Intel[®] Pentium[®] II Xeon[™] Processor Specification Update

Release Date: October 2000

Order Number: 243776-025

The Pentium[®] II Xeon processor may contain design defects or errors known as errata which may cause the product to deviate from published specifications. Current characterized errata are documented in this Specification Update.

Figure 1. An Example of Microcontroller Driven Thermal Management

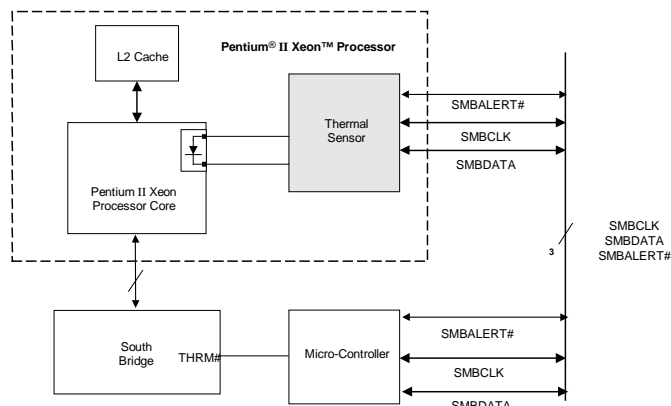
D30. Thermal Sensor May Assert SMBALERT# Incorrectly

Problem: The Pentium II Xeon processor has a thermal sensor that monitors the processor core's temperature. The thermal sensor asserts SMBALERT# if the processor temperature exceeds the temperature limits set in the Alarm Threshold Registers (T_{HIGH} , T_{LOW}). It also sets the corresponding Status Register bits to identify the cause of the interrupt. Figure 1 gives one example of the how the SMBALERT# signal could be used in a system.

Under the conditions described below, the thermal sensor incorrectly generates the SMBALERT# interrupt. All of the following conditions must be met to trigger a false interrupt:

Workaround: Three different (mutually exclusive) workarounds are possible:

1. Before servicing an interrupt from the thermal sensor, read and compare the processor thermal reading with the threshold limits (T_{HIGH} or T_{LOW}). Figures 2 and 3 provide basic flowcharts for the implementation of this workaround in an interrupt driven system.
2. If the firmware implemented polls the Status Register only, then before taking any action, re-read the temperature register and do a comparison with the alarm threshold limits (T_{HIGH} or T_{LOW}) to determine if the value is actually still within the temperature window.
3. Use a temperature polling scheme to monitor the processor temperature
